# RECALL ACTION BULLETIN

**Bull. N°: A/B/D216**

<b>MODEL/DERIVATIVE</b> <b>Discovery Series II V8 Petrol All models</b>	<b>AFFECTED RANGE:</b> <b>XA200611 to YA277051</b> <b>XA900000 to XA907212</b>
<b>Range Rover V8 Petrol</b>	<b>XA410482 to YA443347</b>
<b>Build date</b>	<b>27 August 1998 to 03 April 2000</b>

### **IDLER PULLEY – PREMATURE FAILURE**

**Fig 1 - Discovery Series II**  
Air conditioning/ACE & Power Assisted Steering

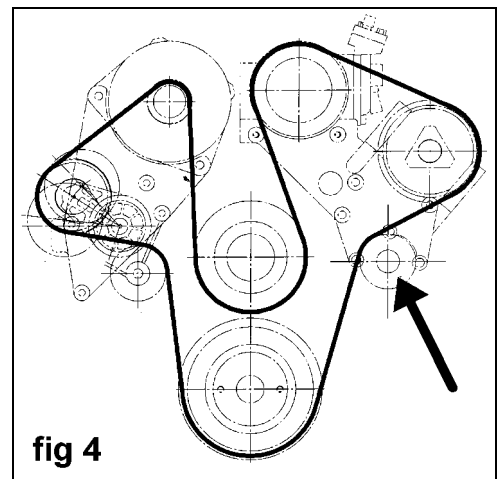
- Refer to the workshop manual for instructions on drive belt removal.
- Remove the idler pulley as identified by the arrow in illustration fig 1.
- Fit new idler pulley PQR101150K, ensure that it rotates freely and that the inner bore of the pulley does not contact the cast webs of its mounting. Should the pulley contact the cast webs carefully fettle the web to provide clearance, tighten the pulley bolt to 50 Nm.
- Ensure the belt is correctly located in all pulley grooves, apply clockwise pressure to the tensioner pulley to tension the belt and tighten the tensioner pulley to 45 Nm.

- Apply a white paint identification to the pulley bolt head as a visual identification that this work has been completed.
- Endorse the service record book.
- Remove the idler pulley as identified by the arrow in the illustrations below.
